Construction Division
Additions & Alteration Charges Approval Form

Company Name:	Modi Properties Pvt Ltd	Site	May Flower Platinum
Name of the customer	Seshank reddy C - 104		
Villa/ Flat No.

MAYFLOWER PLATINUM

Details of Additions & Alterations

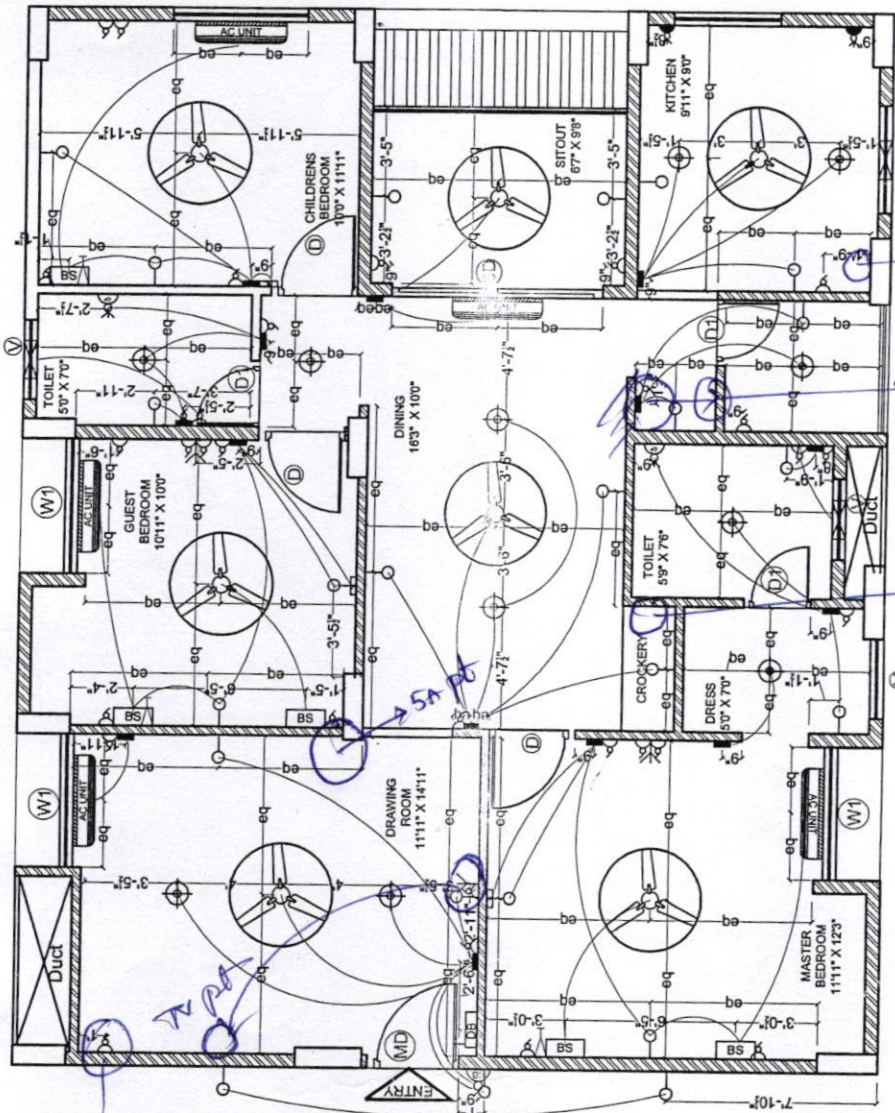
Choice of Bathroom tiles, CP fittings & Sanitary ware:

- 1) Utility wall cladding & flooring to be Country Blackberry.
- 2) Both bathrooms to be Luna Series tiles. (Not done)
- 3) Sink to be shifted to utility corner in kitchen as marked.
- 4) Wash basin provision in dining to be shifted to utility as marked.

ELECTRICAL PLAN OF FLAT-C4

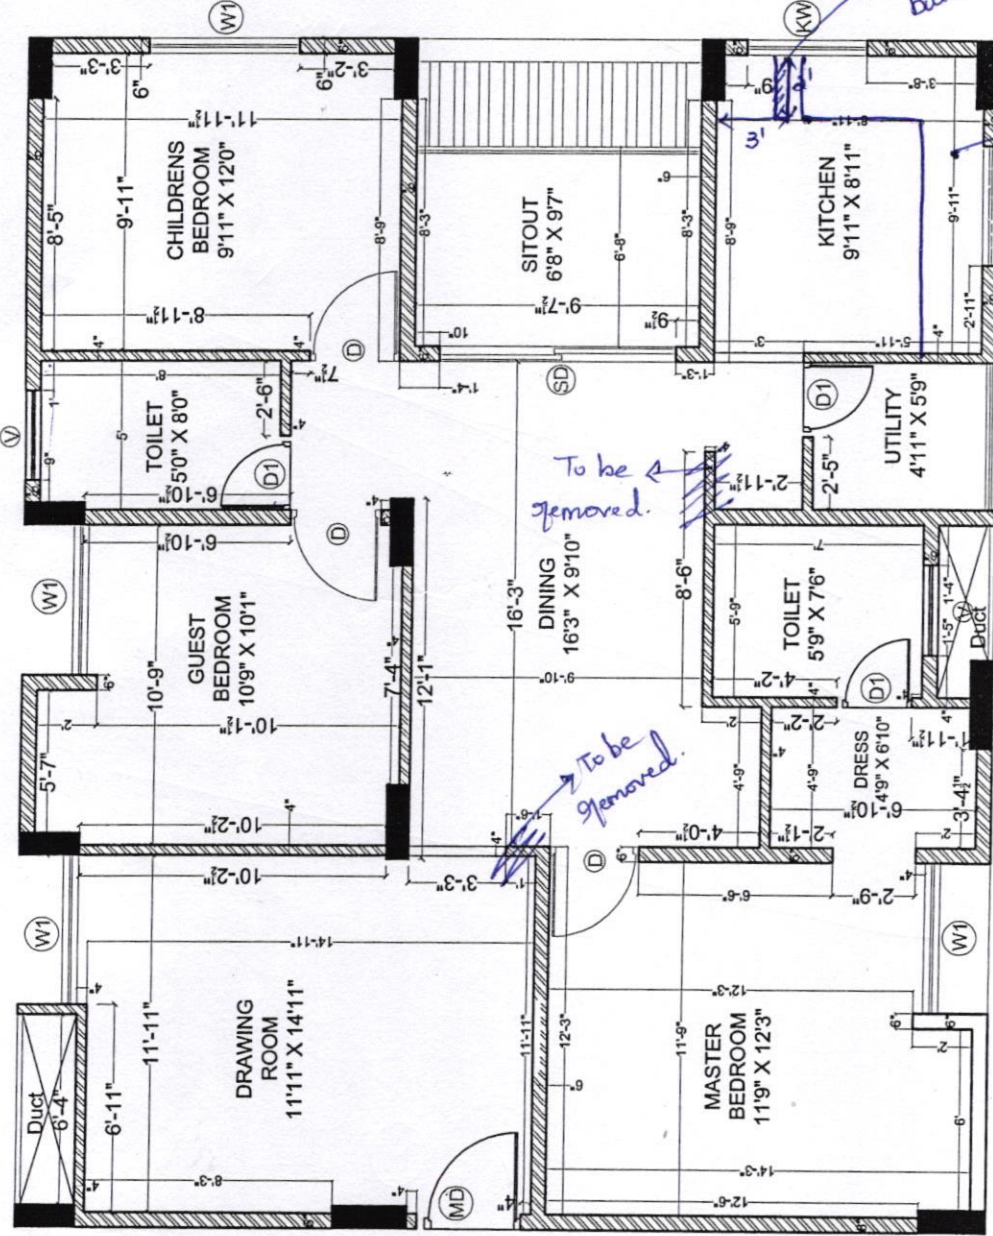
Changes in electrical points: (mark on plan)

- 1) Aqua point to be shifted on sink as marked.
- 2) ISA point at utility to be given.
- 3) ISA point in dining to be given at Grockery Unit
- 4) TV point to be shifted in drawing room.
- 5) extra SA point to be given.

Description	Direction	Owners & Developers :	Date :	Promot
WORKING DRAWING OF FLAT.NO.C-4	N	Modi Properties Pvt Ltd.	18.08.2020	
		Project Name & Phase :	Prepared By :	
		MAYFLOWR PLATINUM	Approved By : Soham Modi	
			Scale : N.T.S	
				Modi Properties Pvt. Ltd Phone:+91-40-66335551

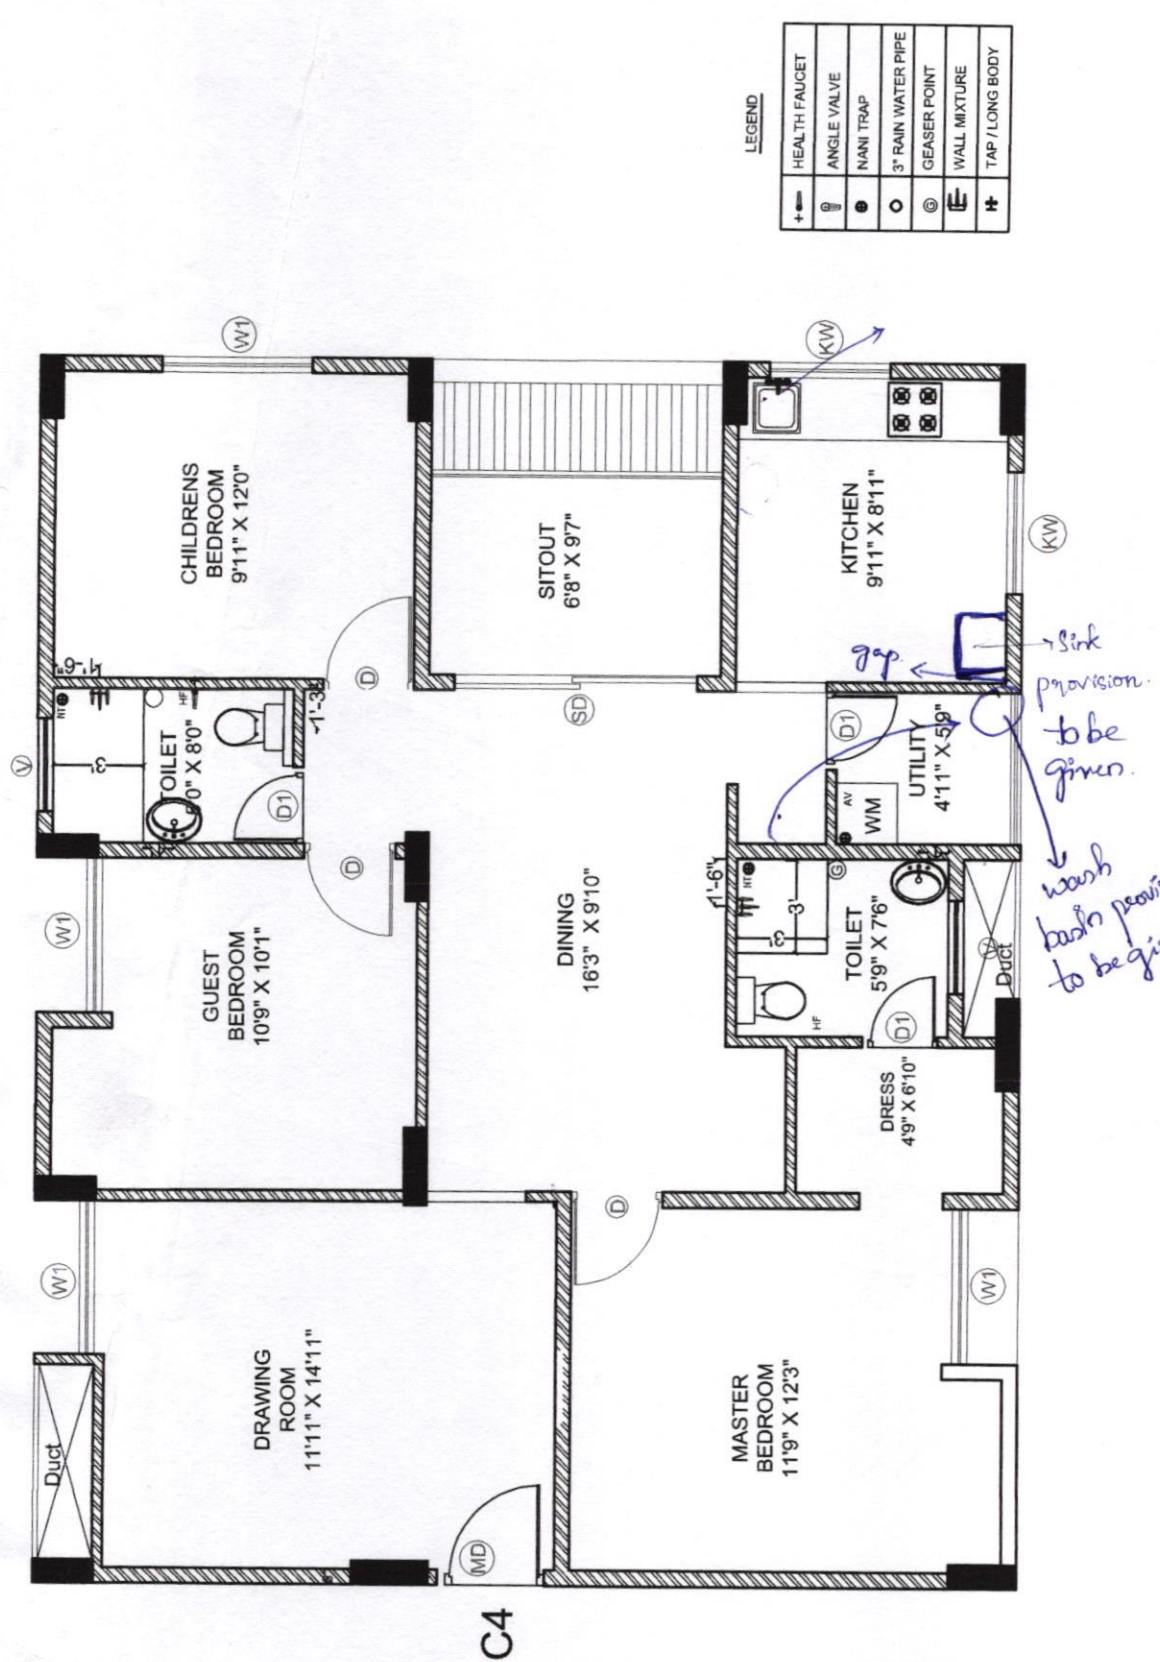
Changes in kitchen platform: (mark on plan)

1) platform to be provided with gatti to water drain.

Other Changes:

1) Wall in drawing of Opp to Utility to be removed as marked.

2) Wall for pooja to be built in kitchen as marked dist.

3) All windows to be 3 track + mesh.
